DEVELOPMENT REVIEW COMMITTEE (DRC) COMMENT REPORT

PROJECT NAME: The Arcadian

CASE NUMBER: UDP-S21043

REQUEST: Site Plan Level II Review: 492 Multifamily Residential Units, 7,350 Square Feet of Restaurant Use and 7,350 Square Feet of Retail Use with Associated Parking Reduction in the Northwest Regional Activity Center

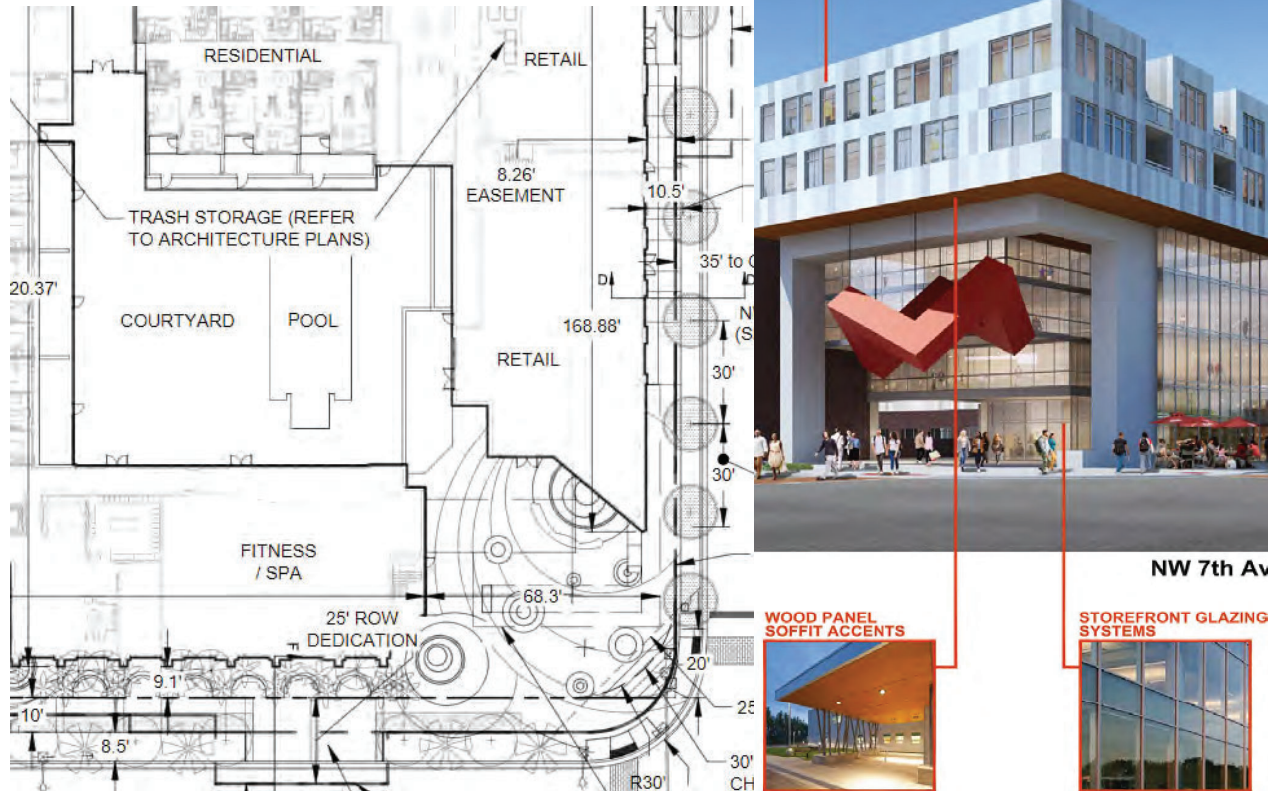
- i. Label renderings.
 - j. Consider CDTEd principles and increase size and height of paseo. Create potential for outdoor seating.
 - k. Increase horizontal and roofline articulation.

- l. Incorporate features on building corners including increased floor height, plaza depth and opportunities for outdoor seating.

See examples below:
